SUBJECT: REQUEST FOR ADDITIONAL INFORMATION FOR THE REVIEW OF THE
MODEL NO. HI-STAR 100MB PACKAGE

Request for Additional Information
HOLTEC INTERNATIONAL
Docket No. 71-9378
Model No. HI-STAR 100MB Package

By letter dated February 16, 2018, Holtec International submitted an application for the Certificate of Compliance No. 9378 for the Model No. HI-STAR 100 MB transportation package.

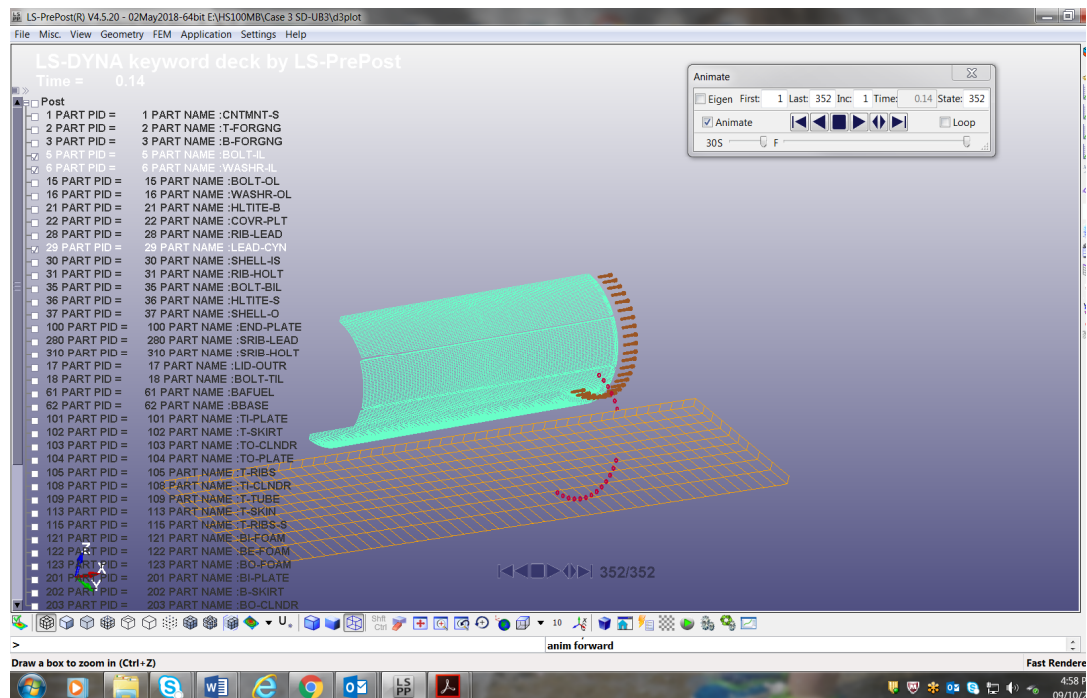
- 4-1 Define clearly the containment boundaries, in Section 4.1 and 4.1.4, to be consistent with the containment boundary shown in Figure 4.1.2 for a single lid cask.

The HI-STAR 100MB includes options for a single lid cask when used with the MPC-32M and a dual lid cask when used with a bare basket, i.e., F-32M or F-24M. Sections 4.1 and 4.1.4 specify that the containment system of the single lid cask consists of the containment shell, containment top flange, containment bottom flange, vent port and drain port cover plates, port cover bolts, outer closure lid with closure bolts, and their respective elastomeric seals (inner seals) and welds.

The staff reviewed the containment boundary shown in Figure 4.1.1 for the dual lid cask and the containment boundary shown in Figure 4.1.2 for the single lid cask and finds inconsistencies in the containment boundary.

In particular, the containment components of the vent and drain port cover plates are not marked in Figure 4.1.2; the test port cover (and its test plug seal), marked in Figure 4.1.2, is not identified as the containment boundary.
